EEG-52

AN EVALUATION OF AIR EFFLUENT AND WORKPLACE RADIOACTIVITY MONITORING AT THE WASTE ISOLATION PILOT PLANT

William T. Bartlett

February 1993

Figure 22. Comparison of CAM Count Rates with Both Detectors Appearing Normal

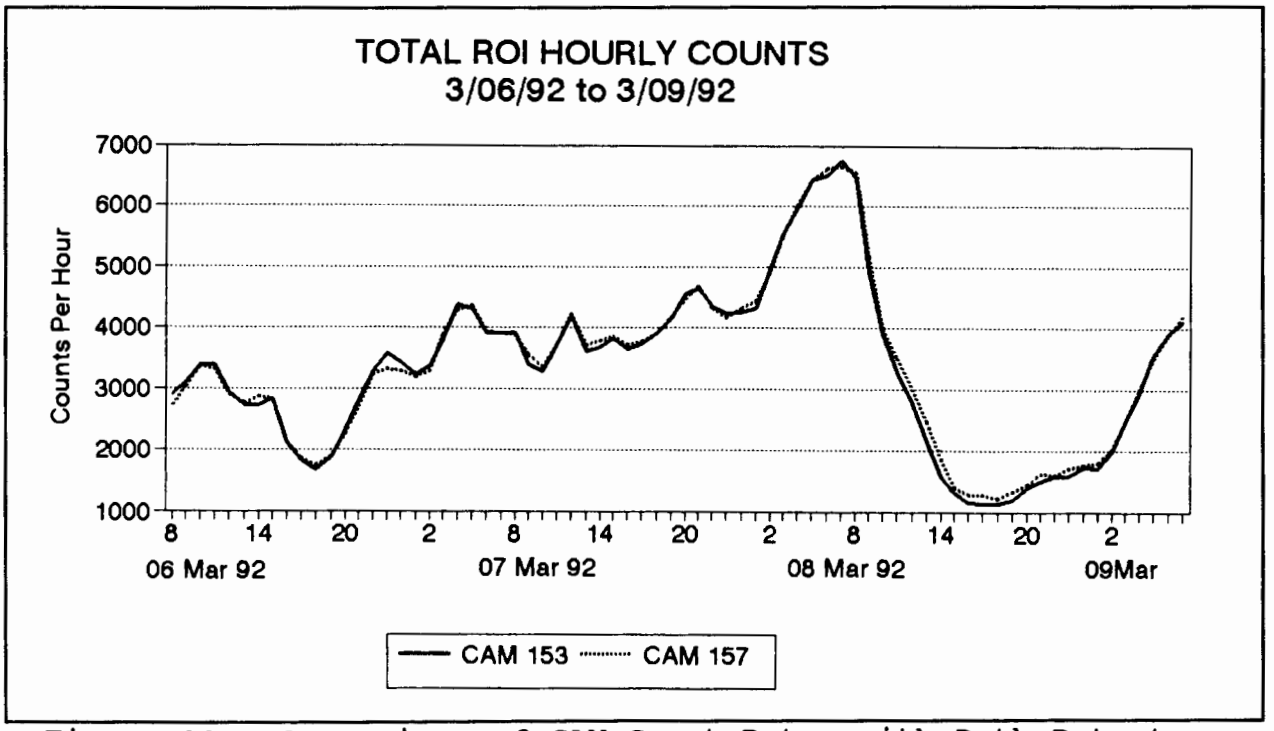
In the second example (3/6/92 to 3/9/92), a week-end (72 hour) sampling period, the average salt loading on filters was very low (0.028 mg/m^3). The CAM 153 and 157 spectra are relatively good (Appendix F-25). The graph of total detector count rate indicates that CAMs 153 and 157 efficiencies track very well

(Figure 22), but graphs of each ROI count rate (Appendix F-26) indicate that ROI 1 and 2 have significantly different count rates. There is an apparent tailing effect in the CAM 157 spectrum (Appendix F-25). The tailing effect may result from detector or detector/filter spacing, but the more likely cause is amplifier non-linearity. Severely degraded CAM 157 spectra on 3/9/92 indicated that the CAM 157 detector failed. Like the 11/22-25/92 example, the plutonium channel minute-by-minute counts do not indicate a detector efficiency problem (Appendix F-27 to F-28).

Figure 23. Comparison of CAM Count Rates with Changing Efficiencies

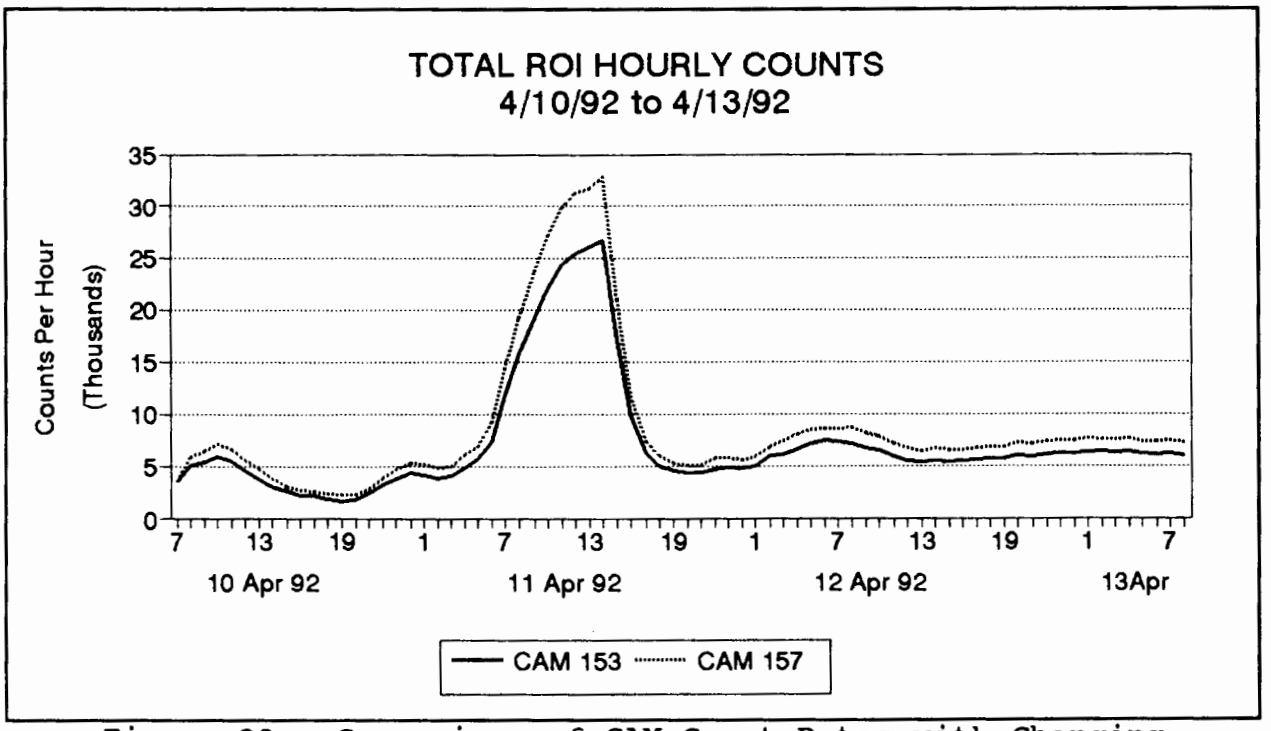
In the third example (4/10/92 to 4/13/92), average salt filter loading was low (0.042 mg/m^3). Both CAM 153 and 157 spectra were good (Appendix F-29), but total detector count rate indicated significant tracking problems when count rate was increased (Figure 23). This phenomenon was also apparent in the ROI count rate graphs (Appendix F-30). Plutonium minute-by-minute channel

data (Appendix F-32) indicate that CAM 157 began having significant negative excursions on 4/11/92, even though CAM 153 was normal (Appendix F-31). This case, like the 3/6/92 example, seems to be the result of poor amplifier performance, although other causes are not ruled out.
